Urgent Field Safety Notice

Title: ORBIS Medication: Adding value for carrier solution leads to two solutions being inserted with same value -> wrong dilution

Internal Reference: MST0073175

- ORBIS Medication 03.18.02.00 in ORBIS 84.40.02.00 and higher in Germany, Austria, Switzerland, Luxembourg - Manufacturer: DH Healthcare GmbH
UDI-DI: 4260693990026

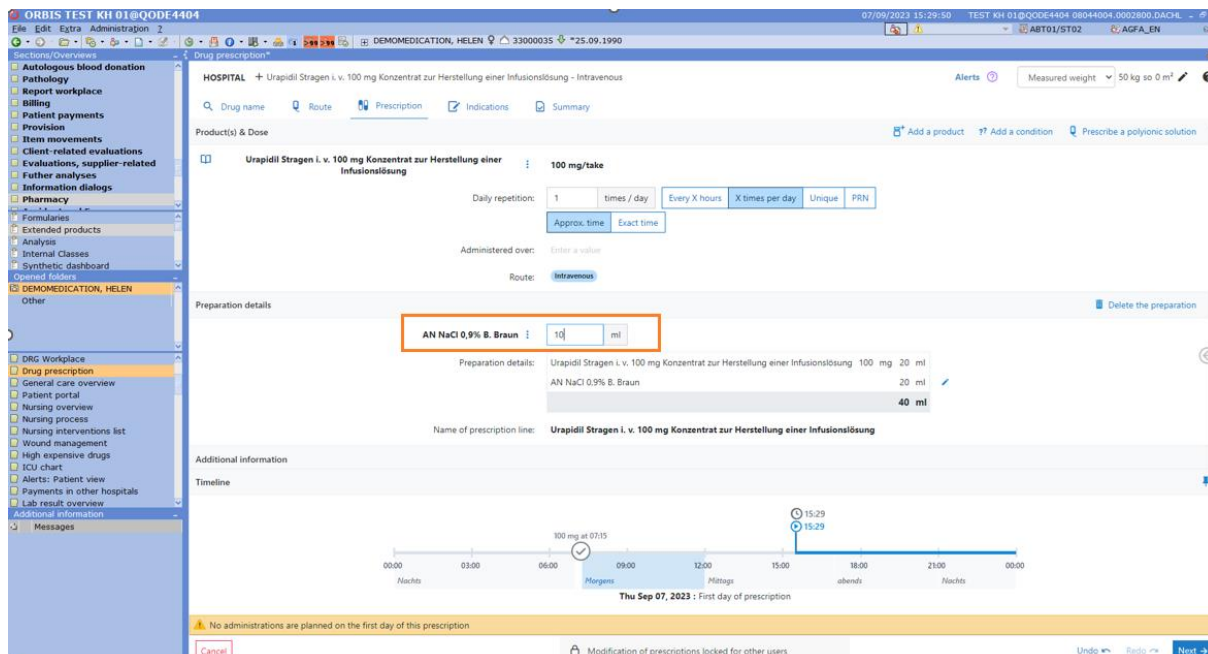
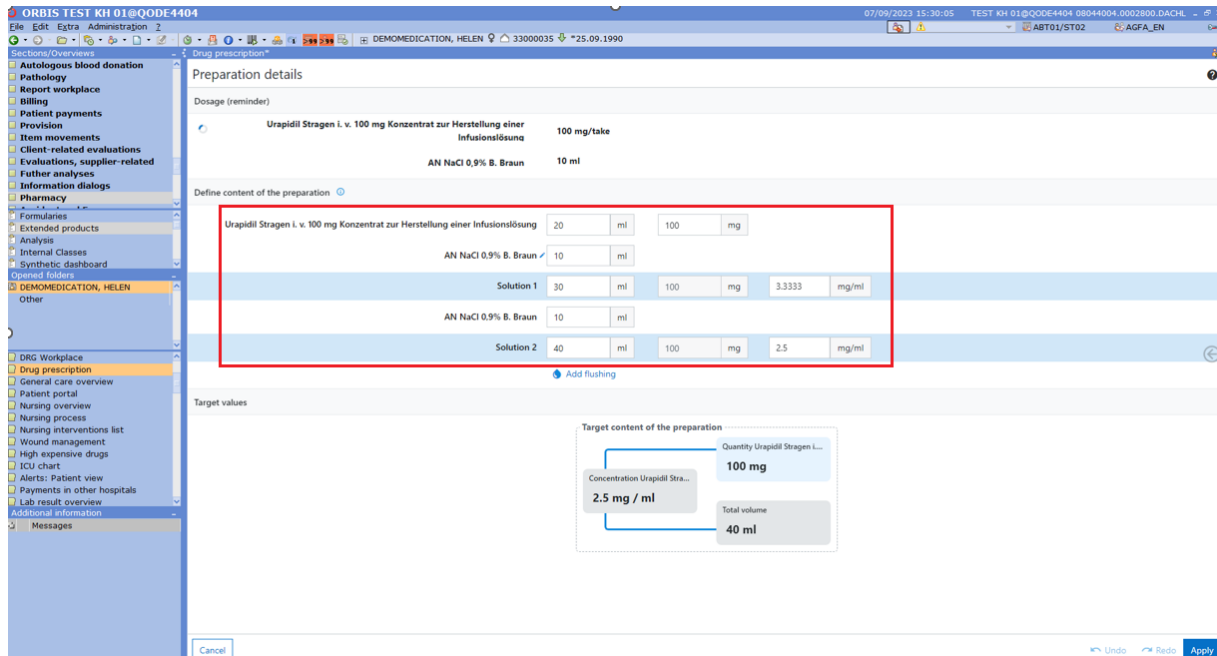
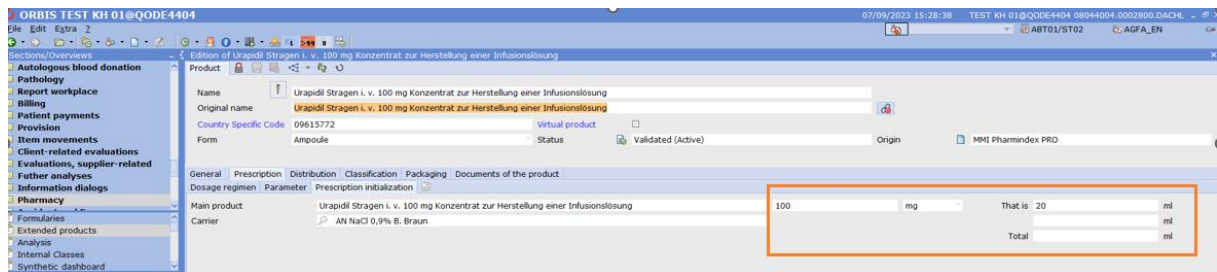
After update to ORBIS Medication 03.18.02.00 or higher, an issue occurs when a product is prescribed with a fixed carrier volume: the preparation details are wrongly initialized, and the physician cannot adapt them properly.

The issue is the following: the drug is prepared with two successive dilutions, the volume of carrier in the first dilution is different from the one defined in product configuration and there is no possibility to prepare the drug in one dilution only.

This wrong initialization of preparation details occurs when the product is configured with a quantity to prepare and (or) a volume of carrier to be used for reconstitution/dilution.

- Inform the affected customers with this letter.
- Release of correction with ORBIS Medication version 03.18.03.01 in ORBIS version 84.40.04.03 (general release planned end of October 2023).

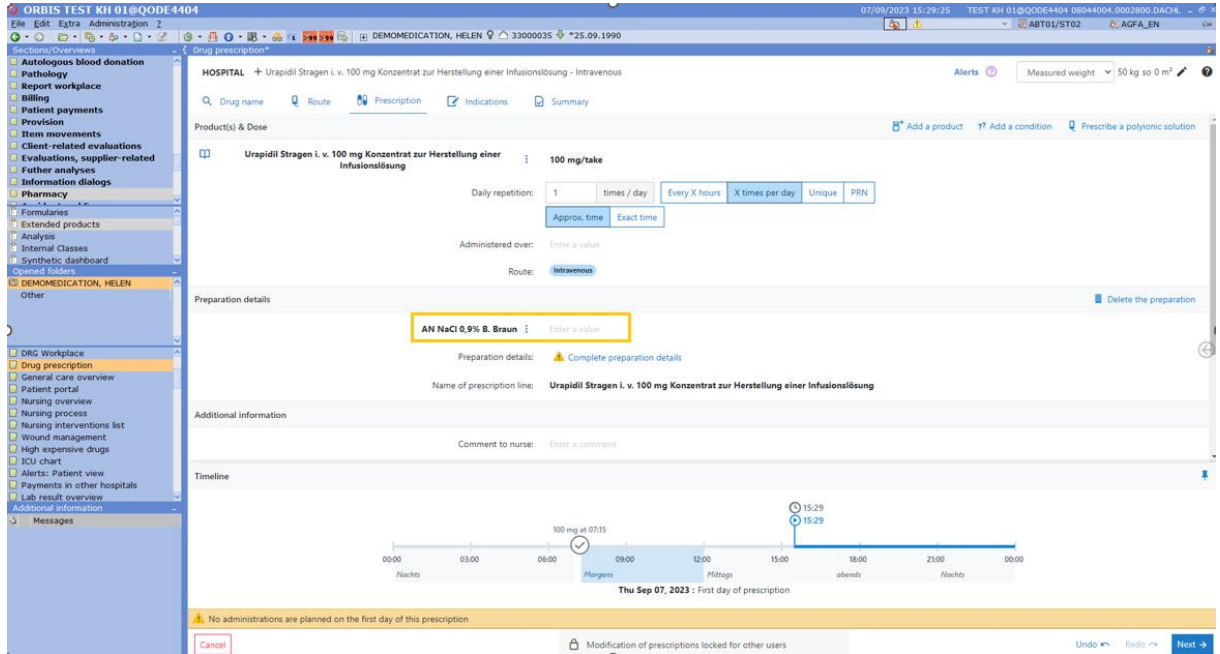
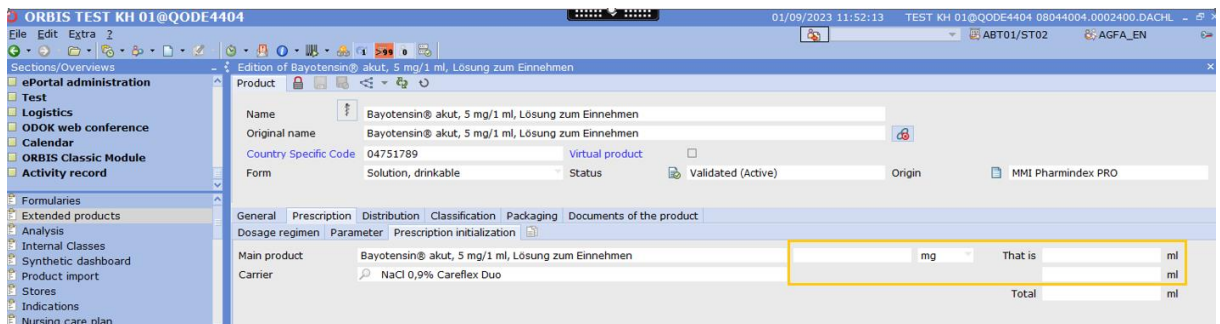
- When prescribing a product with a configured preparation, do not enter a value for the carrier solution in the prescription "Prescription" tab, but open the preparation details screen with the "Complete preparation details" link, and enter the total volume there.

- Another workaround is to modify the product configuration, and remove all quantities set for the initialization of preparation.
